Planning Commission Staff Report

Subject: Treasure
Project #: PL-08-00370
Authors: Francisco Astorga, AICP, Senior Planner
Bruce Erickson, AICP, Planning Director
Date: 11 October 2017
Type of Item: Administrative – Conditional Use Permit
Refinement 17.2 Update / Planning Commission
Outstanding Items

Refinement 17.2 Update

SHEET NO.
COMPARATIVE
SP.1

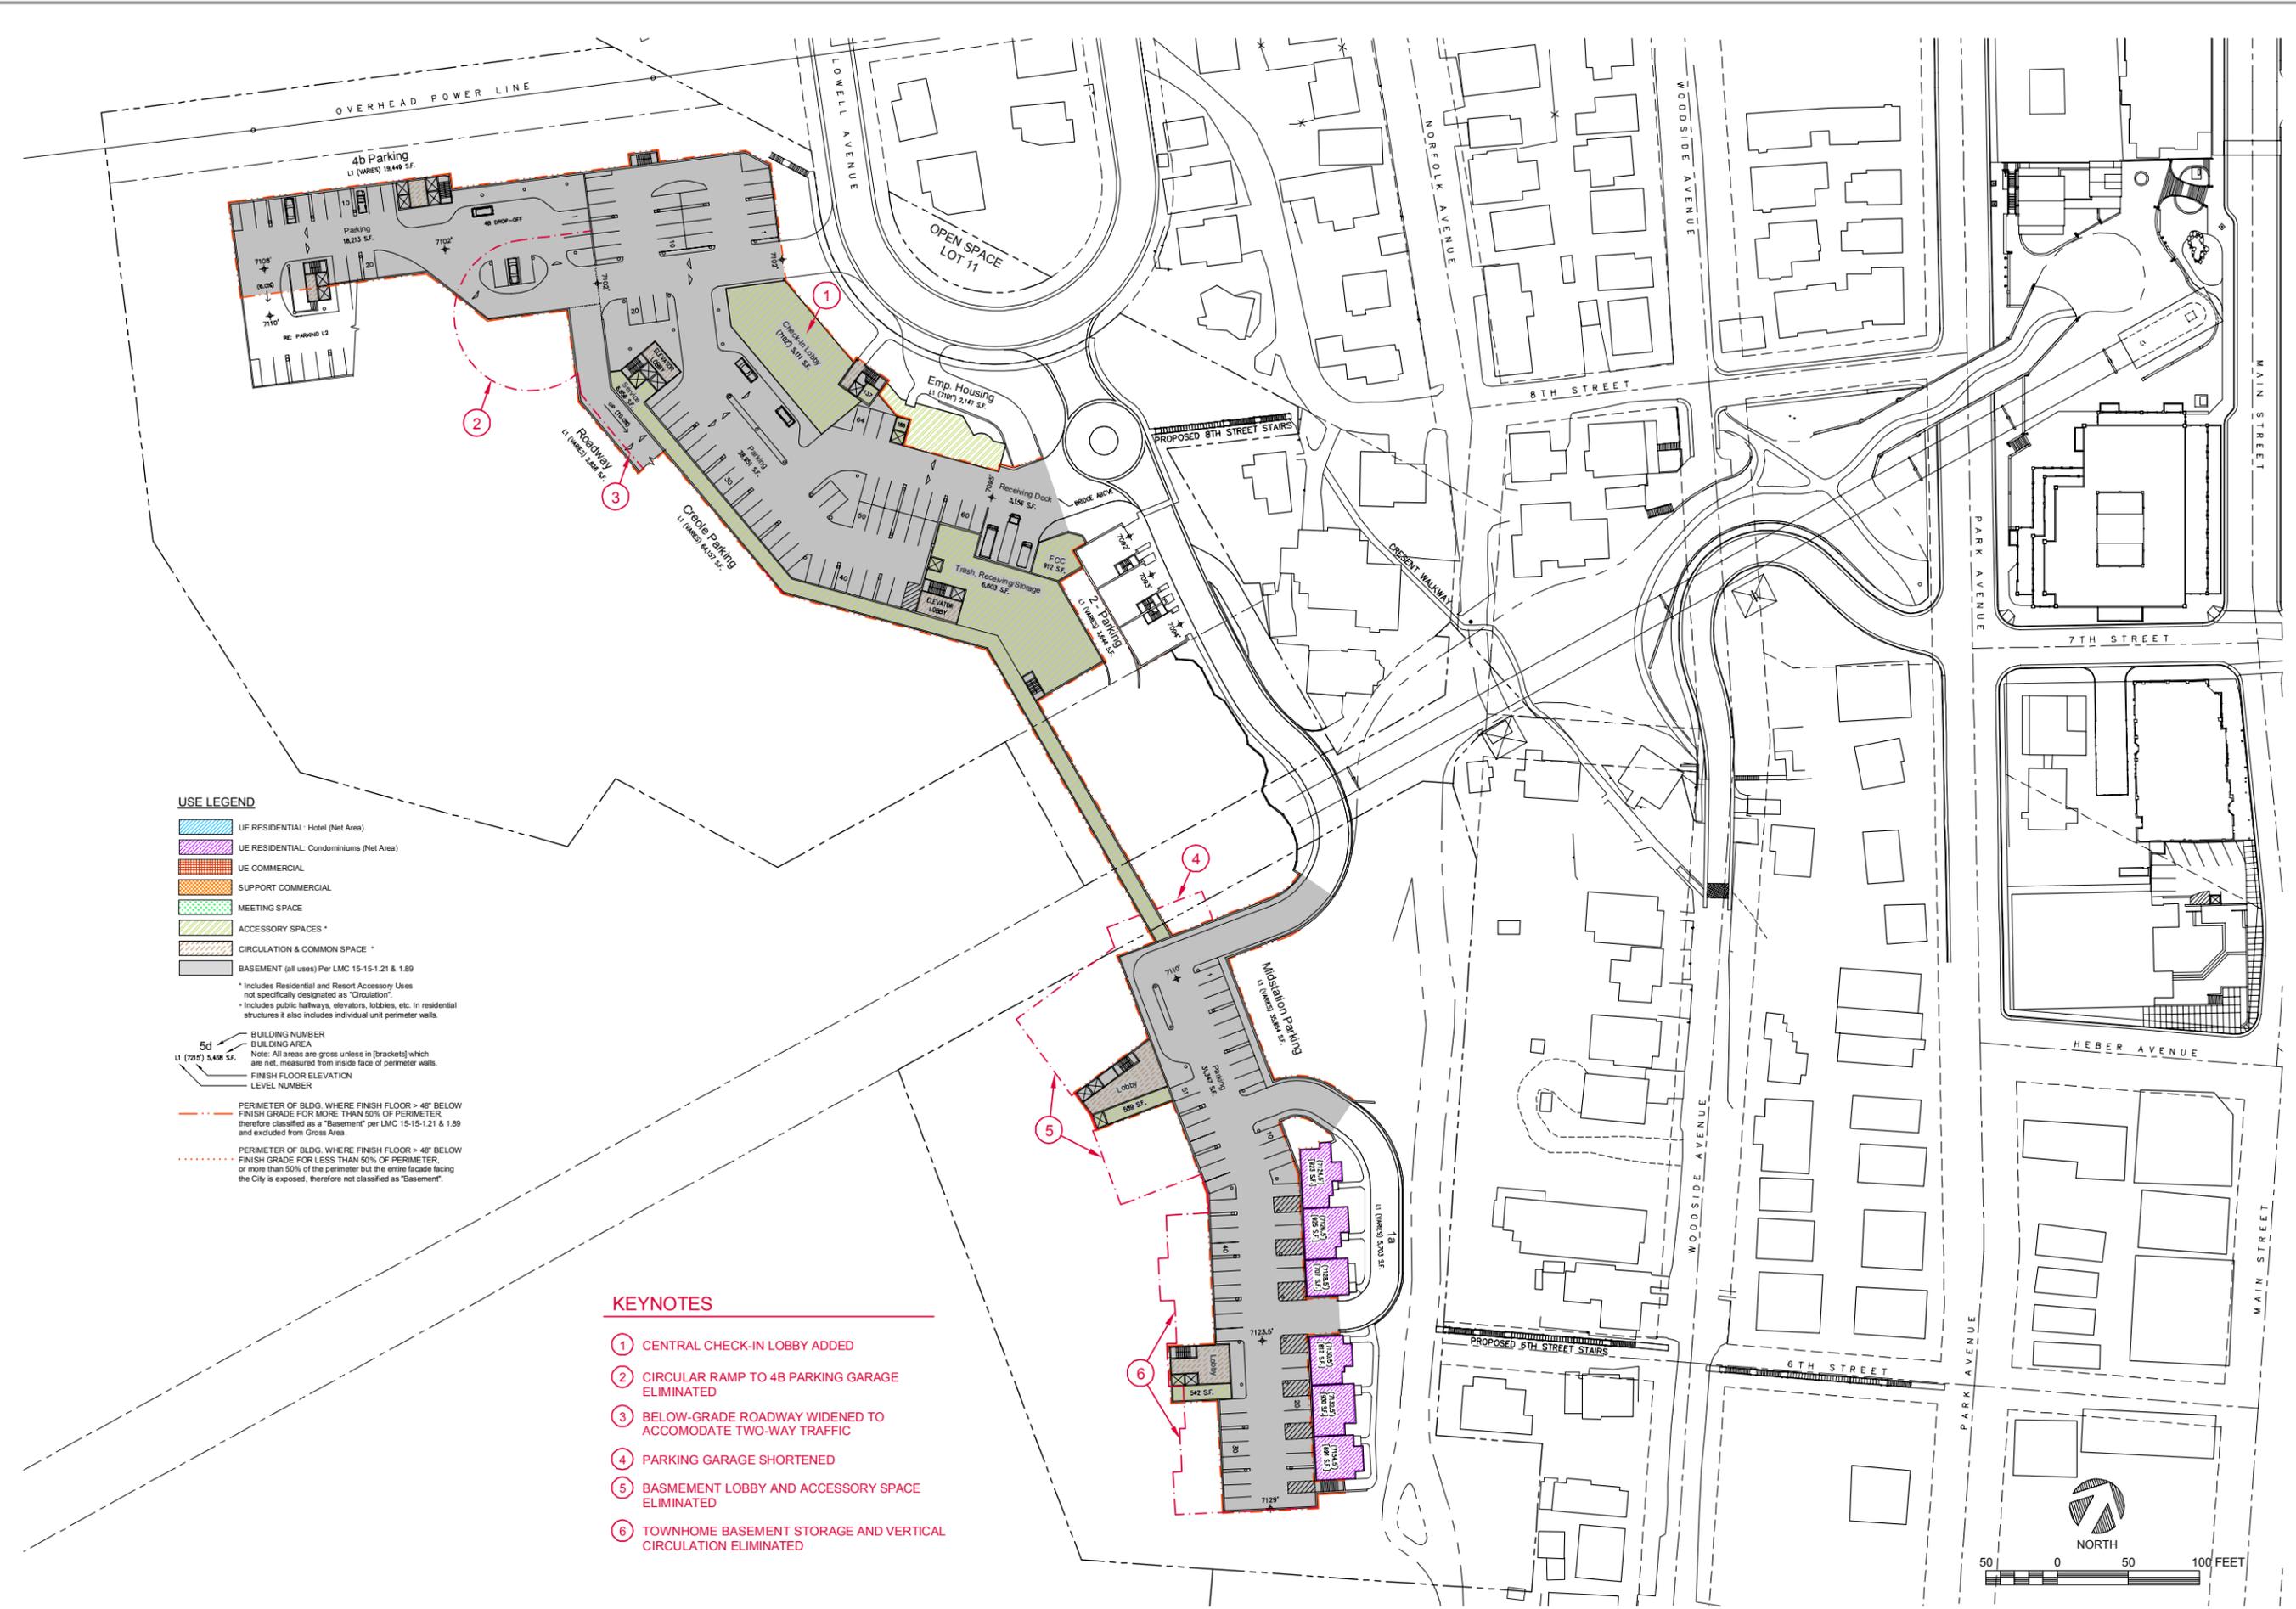
- Site & Circulation Plan ([Sheet No. SP.1 - comparative](#)) keynotes:
 1. Existing grade of Lowell-Empire loop retained rather than lowered.
 2. Entry driveway moved 14' to the South.

3. Moved sidewalk from abutting the curb to inside the right-of-way.
 4. Widened the entry drive to provide occasional round-about in the event either Lowell or Empire is un-passable.

5. Relocated the elevators/stair building.
 6. Reduced the length of the link between buildings 4A & 4B.
 7. Reduced the length of the link between the north and south wings of 4B.

8. Eliminated the pool building and moved it's uses into building 4B.
 9. Eliminated buildings 5b & 5D entirely.
 10. Moved building 5A to the south.
 11. Widened the ski trail.

12. Converted building 5C to flats in lieu of townhomes and moved the building to the west.
 13. Reduced the area of disturbance by approximately 78,000 S.F. or 1.8 acres.

- 4 WIDENED THE ENTRY DRIVE TO PROVIDE OCCASIONAL ROUND-ABOUT IN THE EVENT EITHER LOWELL OR EMPIRE IS UNPASSABLE
- 5 RELOCATED THE ELEVATOR/STAIR BUILDING

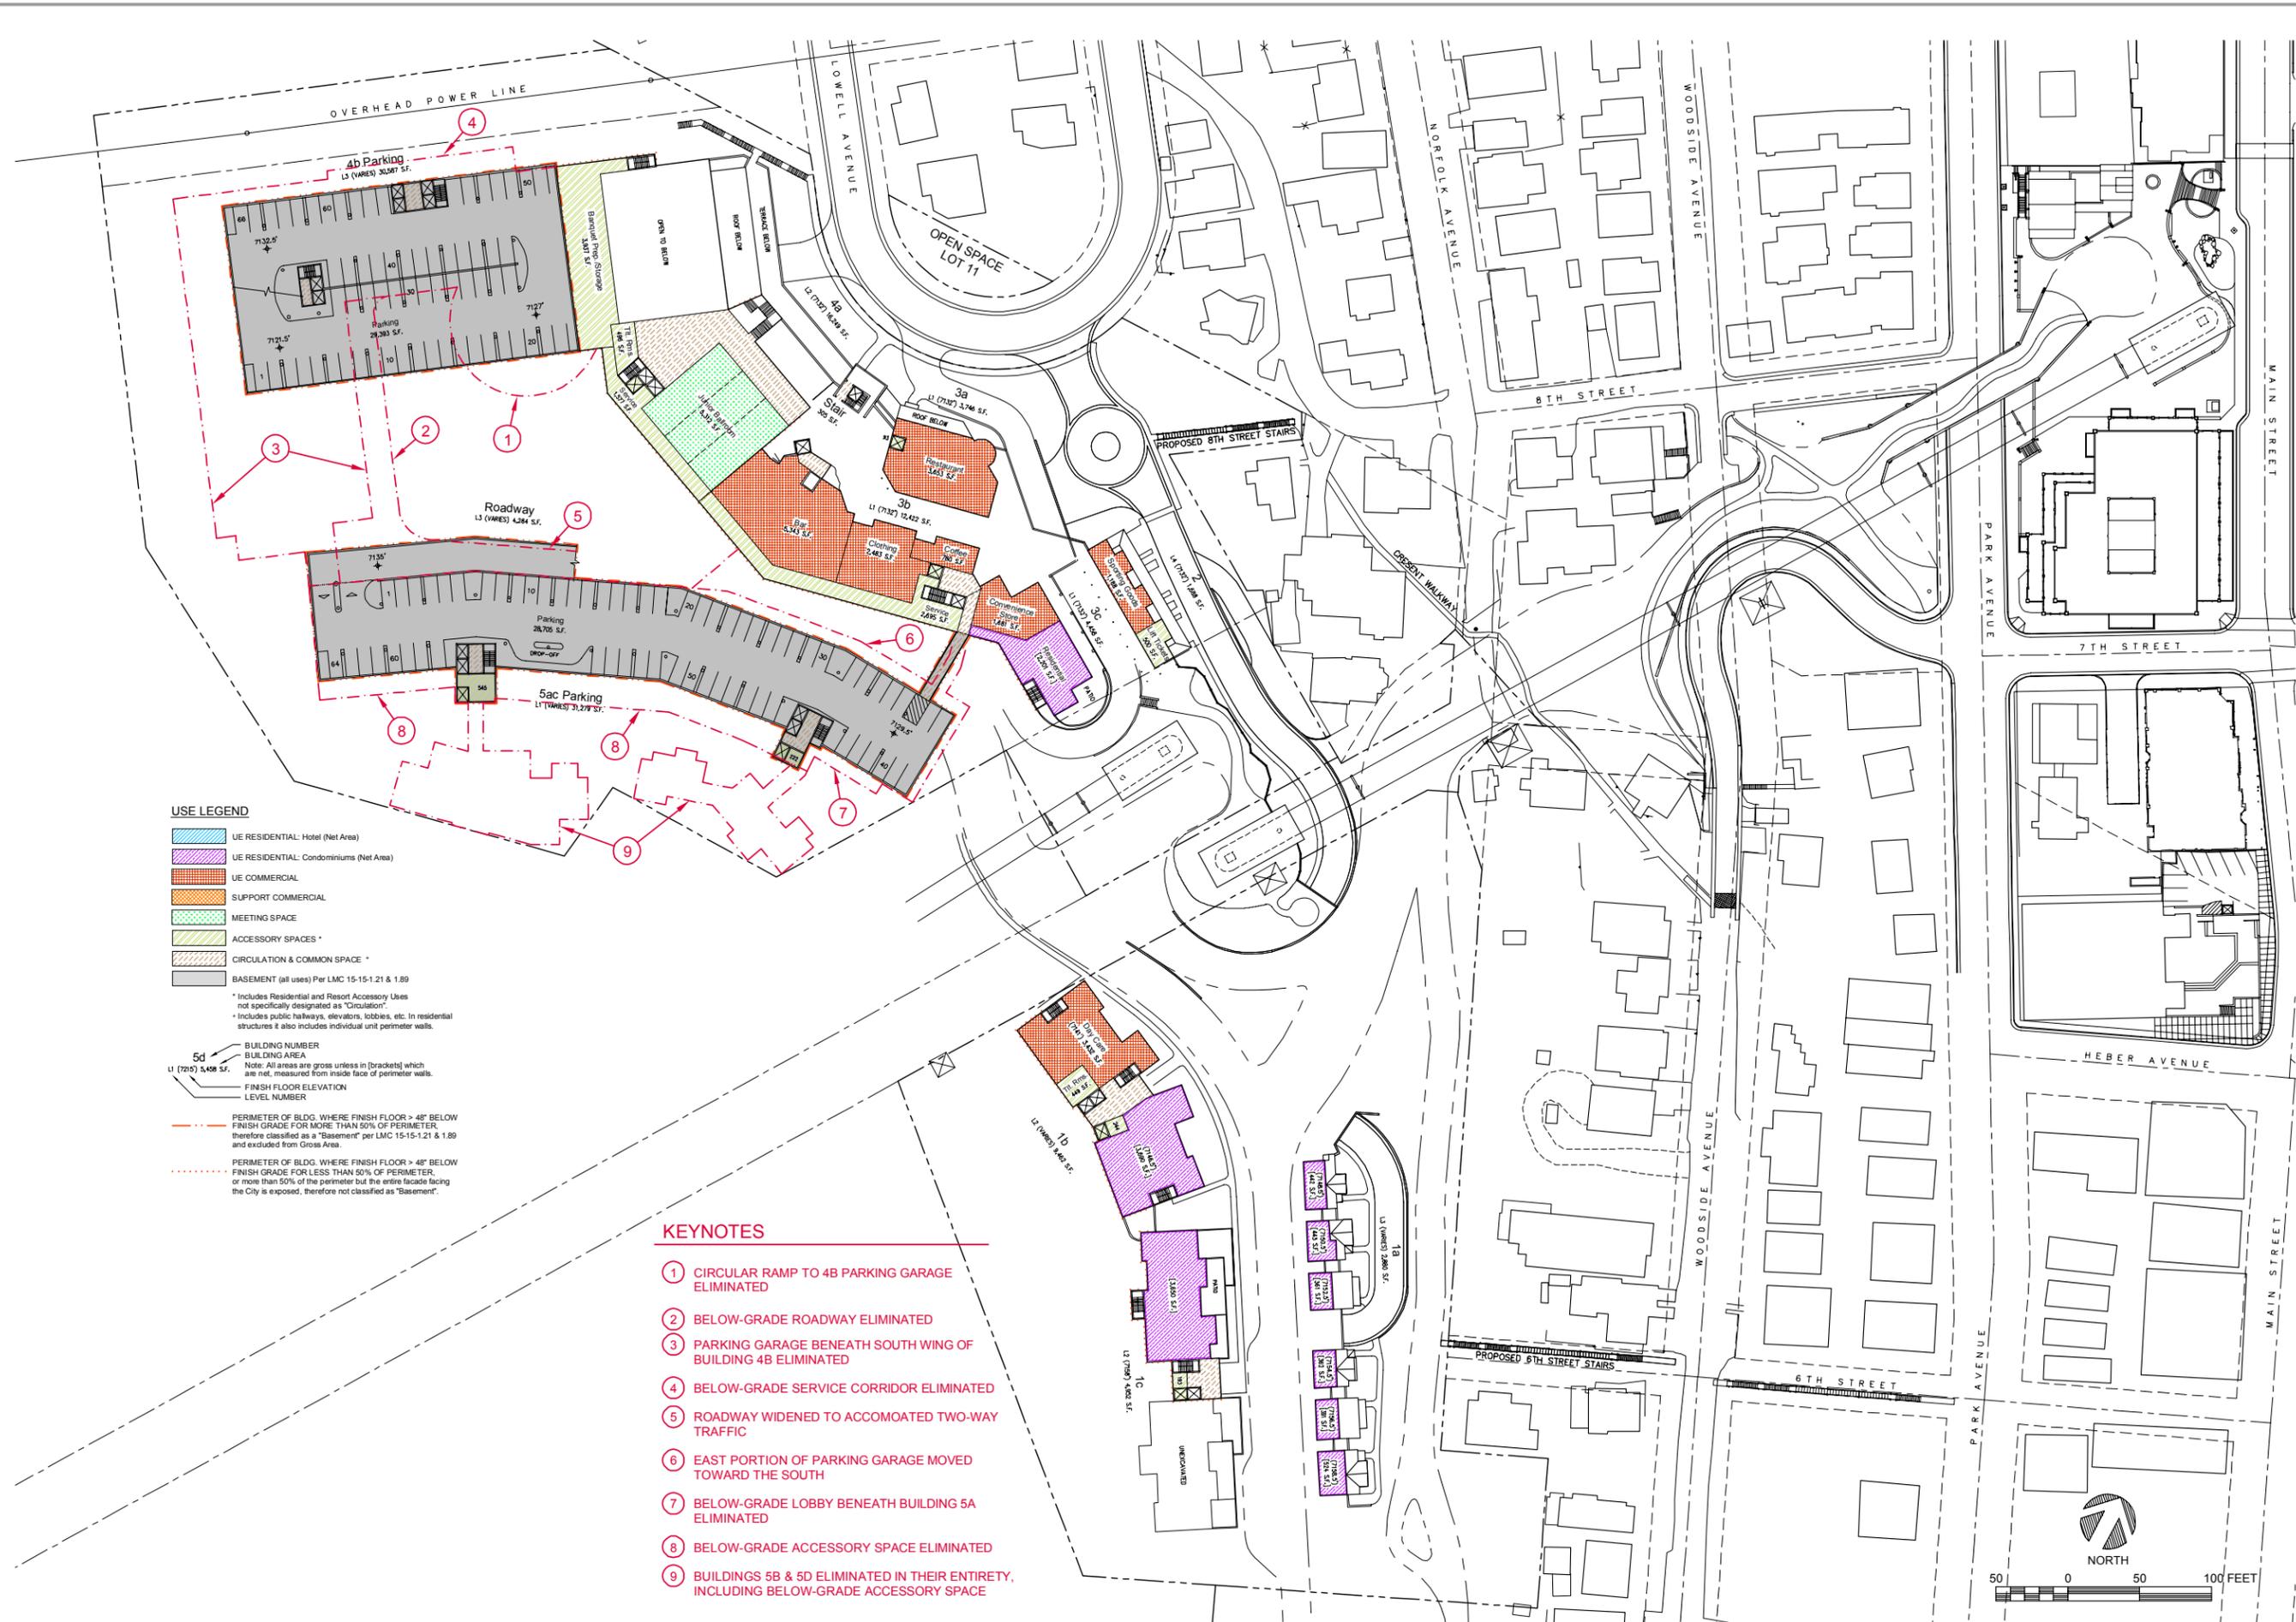
16. Lowered the elevation at the top of cliff-scape approximately 48' and reduced.
- Level 1 Use Plan ([Sheet No. P.1 - comparative](#)) keynotes:
 1. Central check-in lobby added.

SHEET NO.
COMPARATIVE
E1A2.1

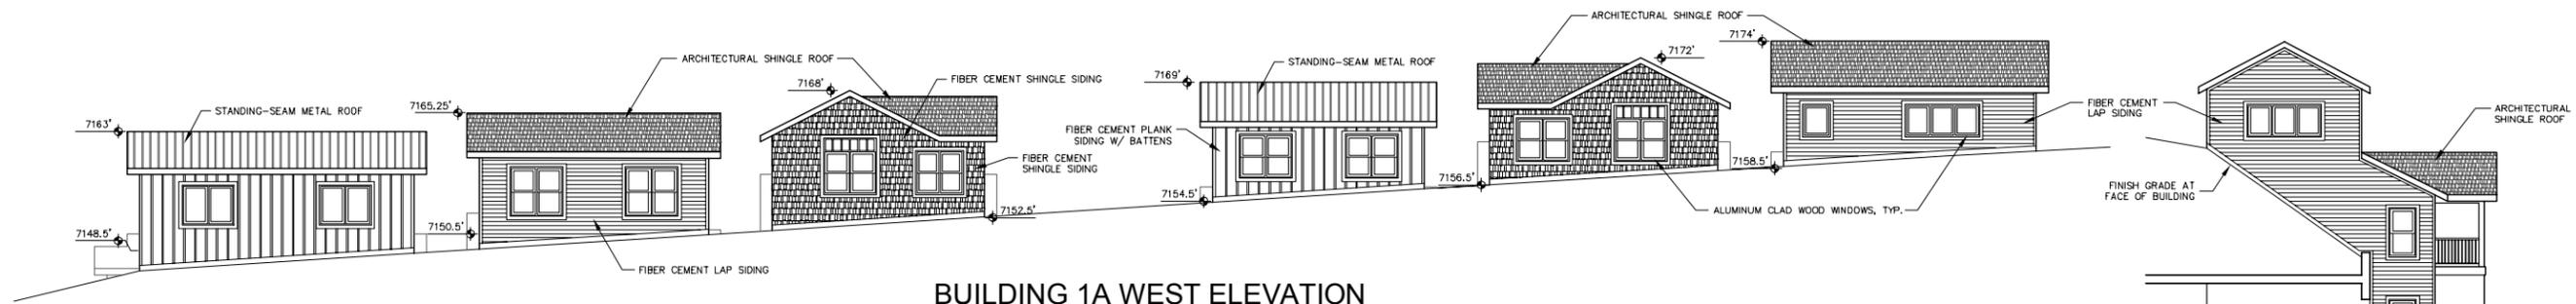
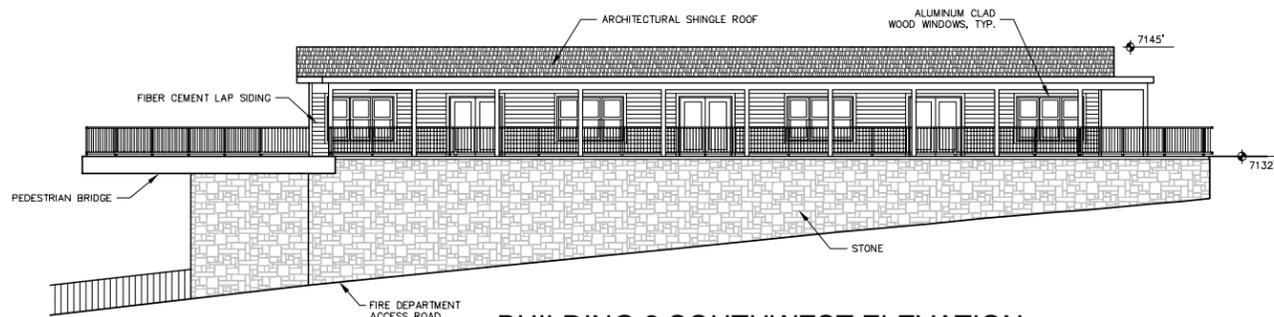
- No change to building 1A east and west elevations.
 - Minimal changes shown with the 2009 building outlined, compared to show difference.

NO CHANGE

SHEET NO.
COMPOSITE
E3BC.1

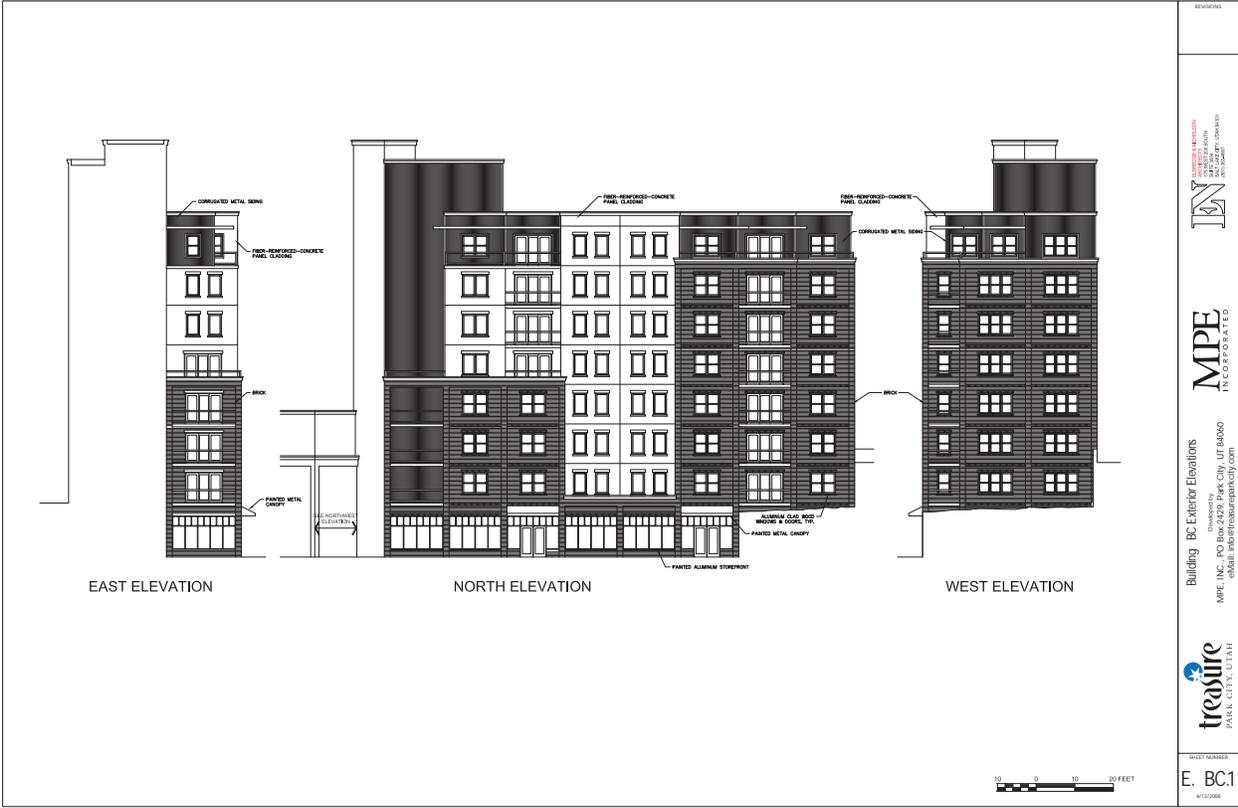
- Building elevation raised to accommodate existing grade at Lowell-Empire loop.
- Building 3BC Exterior Elevations ([Sheet No. E3BC.1 - comparative](#)) notes:

- Changes shown with the 2009 building outlined compared to show difference.
 - Eliminated one story from building 3C.
 - Building Elevation raised to accommodate existing grade at Lowell-Empire loop.

SHEET NO.
COMPOSITE
E4A.1

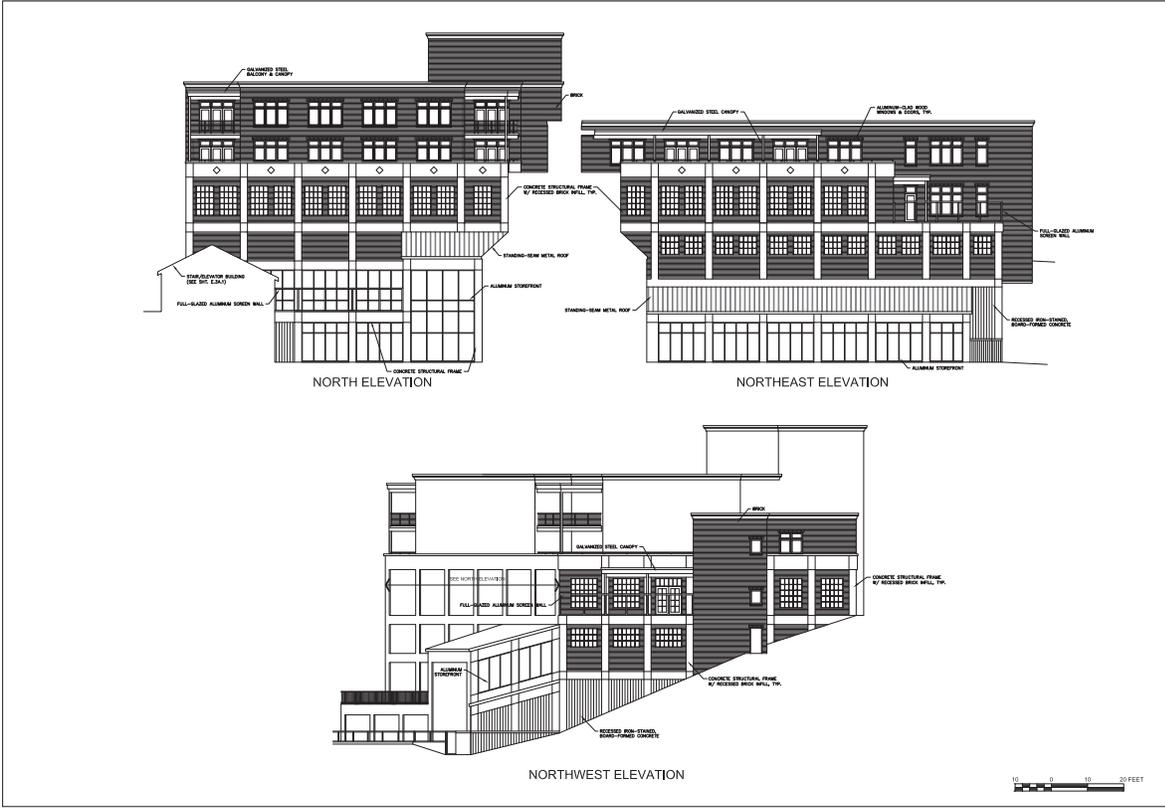
- Building Elevation raised to accommodate existing grade at Lowell-Empire loop.
- Building 4A Exterior Elevations ([Sheet No. E4A.1 - comparative](#)) notes:

- Minimal changes shown with the 2009 building outlined compared to show difference.
 - Building Elevation raised to accommodate existing grade at Lowell-Empire loop.
